<b>Model:</b> PRIPORT PEARL		<b>Date:</b> 31-Dec-98	<b>No:</b> 01
<b>Subject:</b> Pressure Cylinder Maintenance Cycle		<b>Prepared by:</b> H. Kokubo,  Priport Service Planning Section	
<b>Classification:</b>	<input type="checkbox"/> Troubleshooting	<input type="checkbox"/> Part information	<input type="checkbox"/> Action required
	<input type="checkbox"/> Mechanical	<input type="checkbox"/> Electrical	<input checked="" type="checkbox"/> Service manual revision
	<input type="checkbox"/> Paper path	<input type="checkbox"/> Transmit/receive	<input type="checkbox"/> Retrofit information
	<input type="checkbox"/> Other (      )		
<b>Model Name:</b> PEARL: Ricoh JP5000, Gestetner 5450, RexRotary 1560, nashuatec CP450, SVN 3350DNP

<b>Model:</b> PRIPORT PEARL		<b>Date:</b> 31-Dec-98	<b>No:</b> 02
<b>Subject:</b> Master Feed Jams or Cutter Errors		<b>Prepared by:</b> H. Kokubo, Priport Service Planning Section	
<b>Classification:</b>	<input checked="" type="checkbox"/> Troubleshooting	<input checked="" type="checkbox"/> Part information	<input type="checkbox"/> Action required
	<input type="checkbox"/> Mechanical	<input type="checkbox"/> Electrical	<input type="checkbox"/> Service manual r

### Maintenance Table

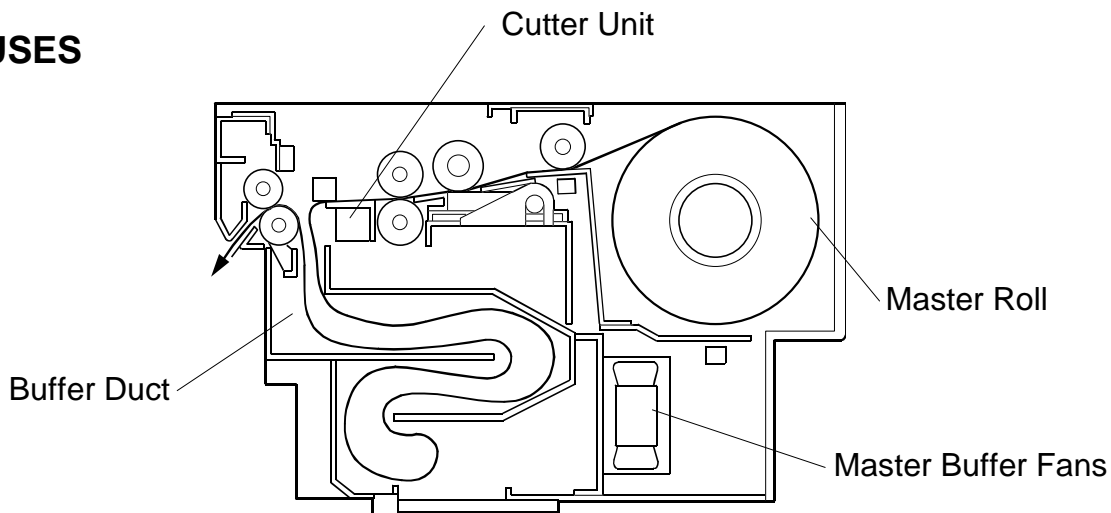
The Preventive Maintenance section in the service manual (page 5-1) shows the pressure cylinder and the paper clamber as consumable PM items. It states that the parts should be replaced every 1.2M copies or every 2 years.

In fact, they do not have to be replaced periodically, but in emergency cases only.

Correct the maintenance method for the pressure cylinder and paper clamber in your service manual as follows:

Item	Interval	Time				Print Counter					EM	NOTE
		6M	1Y	2Y	3Y	300K	600K	1M	1.2M	2M		
Pressure Cylinder	C	C	C	C				C				Damp Cloth
Paper Clamber (on Pressure Cylinder)	C	C	C	C				C				Dry Cloth

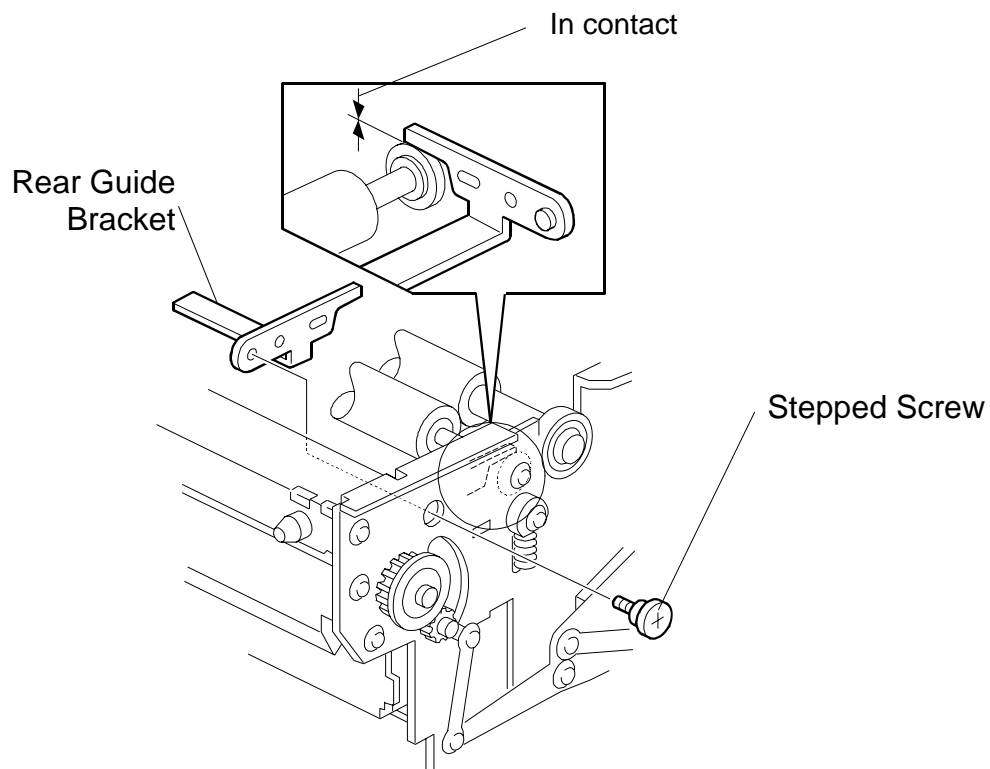
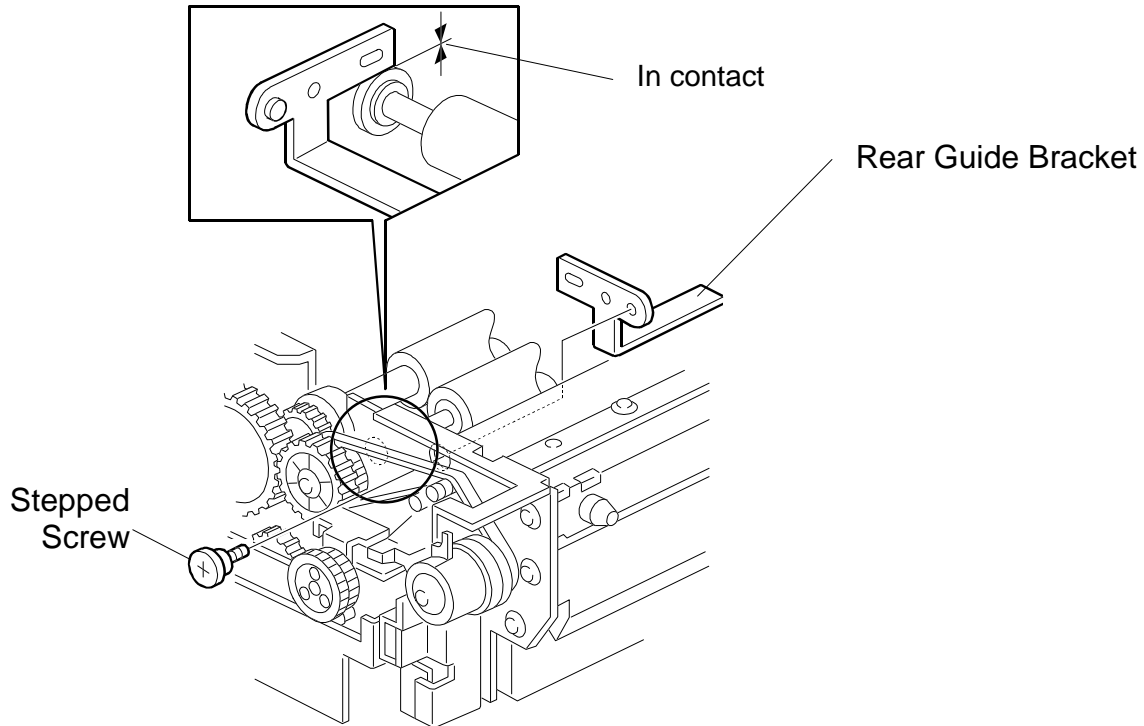
To ensure that the master is guided into the buffer duct, the following parts have been registered as service parts.

**CAUTION:** 1) The two brackets are different. Make sure to install them in the correct positions by referring to the diagrams above.  
 2) Make sure that both brackets are in contact with the flanges of the ball bearings at each end of the roller. (See diagram.)

2. Install the front guide bracket (in the operation side of the unit) using the stepped screw, as shown above.

3. Install the rear guide bracket (in the non-operation side of the unit) using the stepped screw, as shown above.

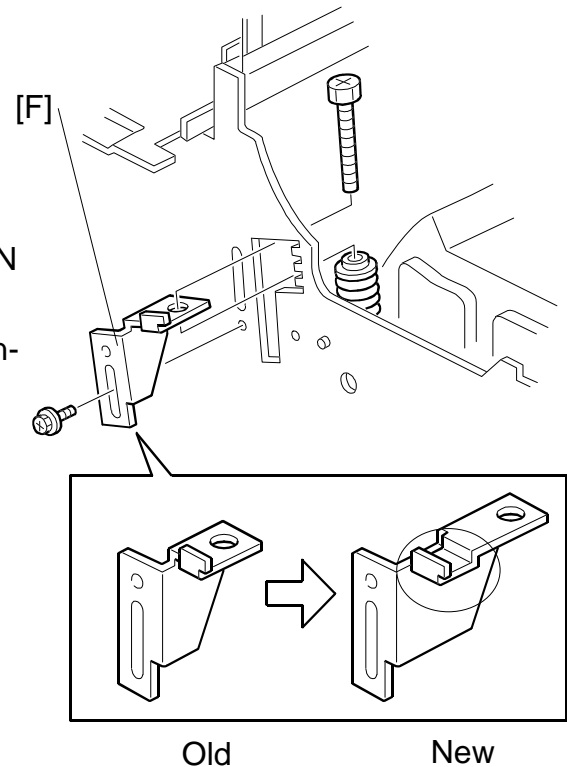
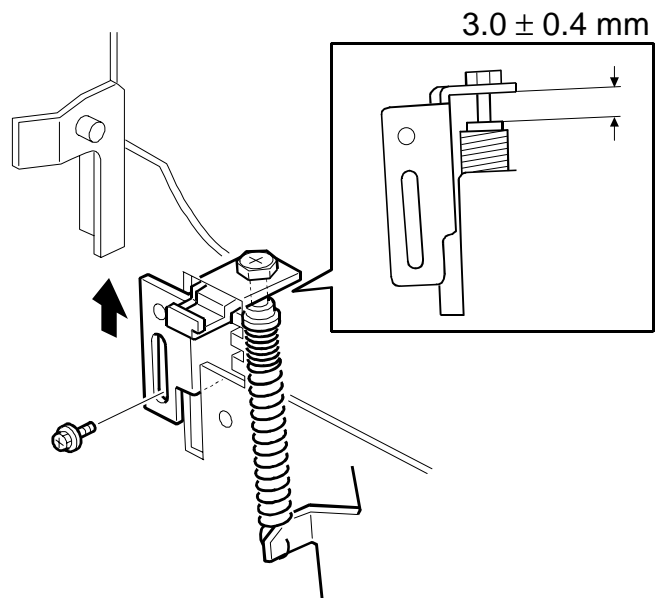
4. Remove the front spring bracket [F] (1 bolt and screw), and install the new front spring bracket (P/N C2293275).
5. Similarly, replace the rear spring bracket at the non-operation side. (P/N C2293276)

**NOTE:** 1) Steps 4 and 5 are required only when you want to install the new brackets.  
 2) The printing pressure can be increased (up to 16 kgf) even without replacing the brackets.

6. At the operation side, adjust the clearance to  $3.0 \pm 0.4$  mm by turning the bolt.
7. Repeat the same procedure on the non-operation side.

**- Adjustment standards for new and old spring brackets -**

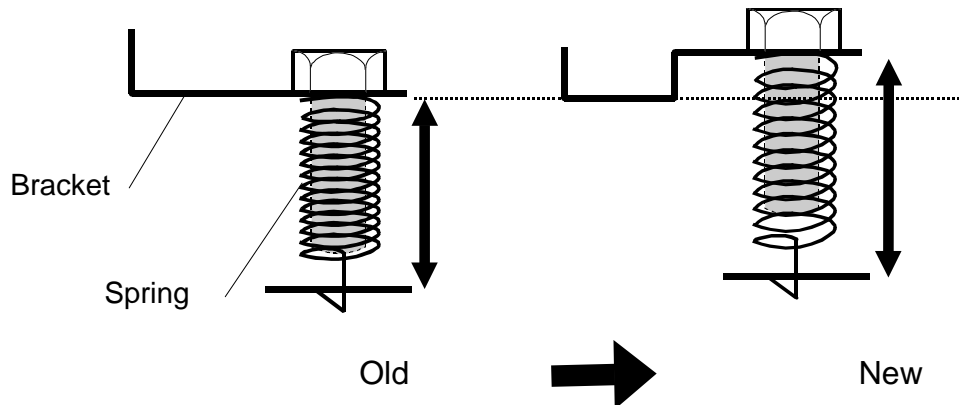
The configurations of the old and new spring brackets as well as the adjustment standard have been changed.

If you do not replace the spring brackets with the new type, set the adjustment value to 0 mm, which means to fully tighten the bolts.

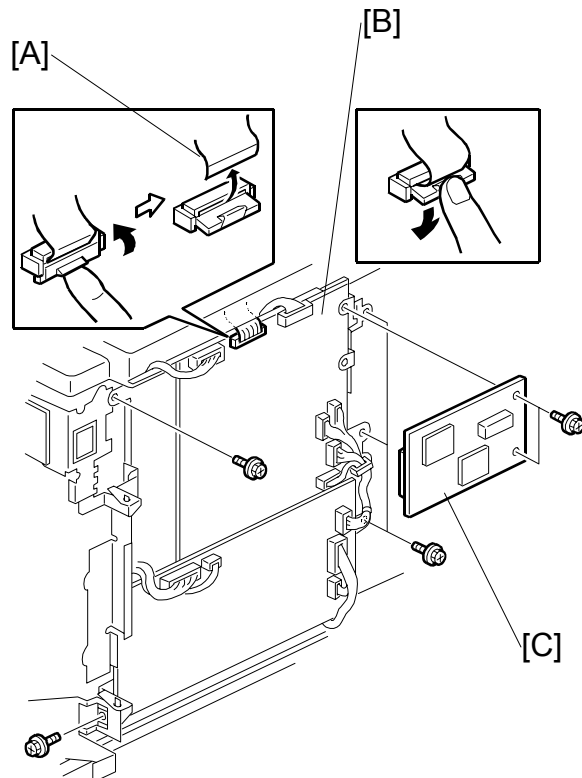
From the July 2000 production, an inspection process has been added at the factory in order to make sure that the sector gear shaft is greased properly.

If the machines serial number is between December 1999 and June 2000 (Serial numbers Cxxx912xxxx to Cxxx006xxxx, or ATx912xxxx to ATx006xxxx), check if the sector gear shaft is greased properly.

**NOTE:** Grease must be applied to where the sector gear plate and sensor actuator bracket contact the shaft surface.

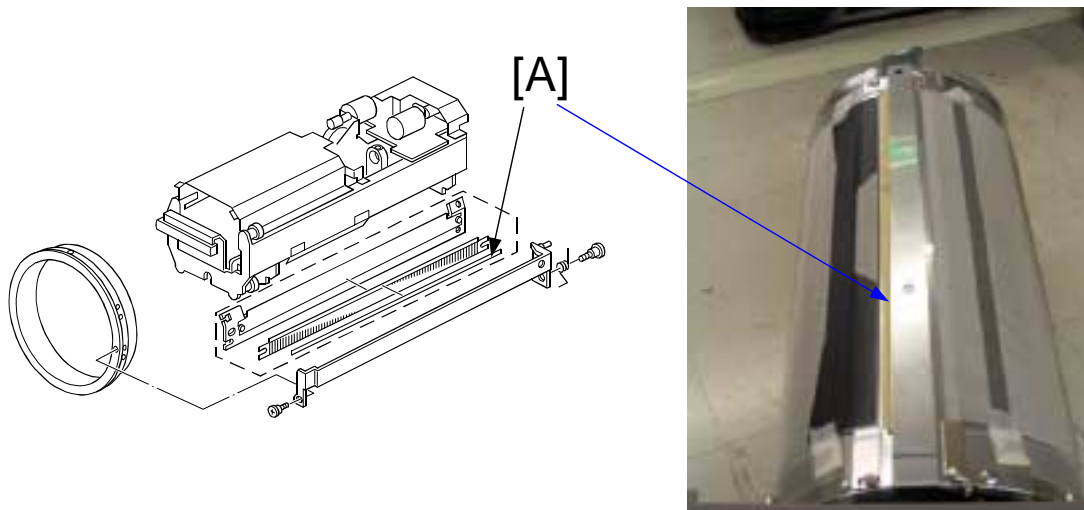
The color of the sandpaper [A] on the clumper base was changed back to similar to its original color from August 2004.

**Change applied from:** August 2004 (color drum production and machine production).
